Access Compliance Report

Public Rights-of-Way

(Curb Ramps)

Intersection ID: 43510	Main Street: MULBERRY_POND_DR	Cross Street: N/A	Location: S
ADA ID: 2C0DC1D45260	Ramp Type: PerpDiag	Initial Pass/Fail: Fail	Overall Compliance: No
Codes/Mitigation Info/Possible Solution		Field Measurements/Component Compliance	
		Severity Score: 10

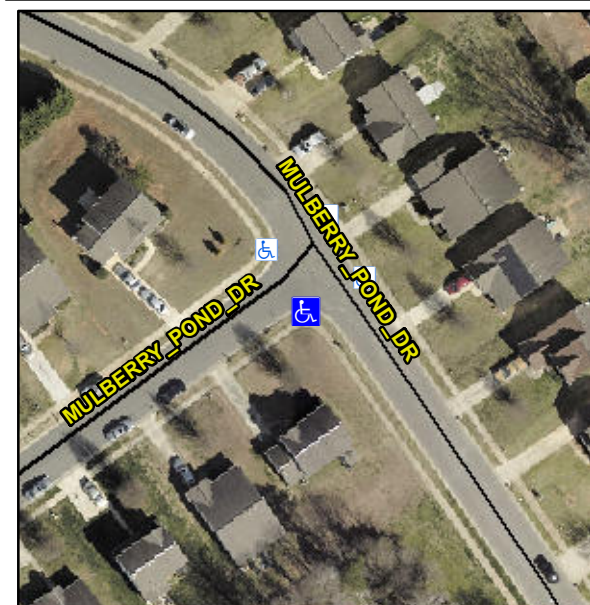
Not Found, R304.5.1, R304.5.3

Compliance	Description	Data	Compliance	Description	Data
N/A	Ramp Length (in)	48.0	Yes	Ramp Slope (%)	5.2
No	Ramp Width (in)	41.0	No	Ramp XSlope (%)	2.4
N/A	Flare Type LT	N/A	N/A	Flare Type RT	N/A
N/A	Flare Slope LT (%)	N/A	N/A	Flare Slope RT (%)	N/A
N/A	Flare Traversable LT?	N/A	N/A	Flare Traversable RT?	N/A
N/A	Landing Length (in)	N/A	N/A	DWS Provided?	N/A
N/A	Landing Width (in)	N/A	N/A	DWS Contrast?	N/A
N/A	Landing Slope (%)	N/A	N/A	DWS Length (in)	N/A
N/A	Landing X Slope (%)	N/A	N/A	DWS Full Width?	N/A
N/A	Landing Curb? (Y/N)	N/A	N/A	DWS Offset (in)	N/A
N/A	Shared Landing?	N/A			
N/A	Gutter Ponding?	N/A	N/A	Gutter Slope (%)	N/A
N/A	Gutter Lip Ht (in)	3.0	N/A	Gutter X Slope (%)	N/A
N/A	Painted X Walk1?	No	N/A	Painted X Walk2?	No
	X Walk 1 Direction	To NE		X Walk 2 Direction	To NW
N/A	X Walk 1 Width (in)	N/A	N/A	X Walk 2 Width (in)	N/A
	X Walk 1 Slope (%)	1.8		X Walk 2 Slope (%)	0.7
	X Walk 1 X Slope (%)	3.0		X Walk 2 X Slope (%)	0.4

Remove & Replace Curb Ramp With Two New Directional Ramps or Equivalent.
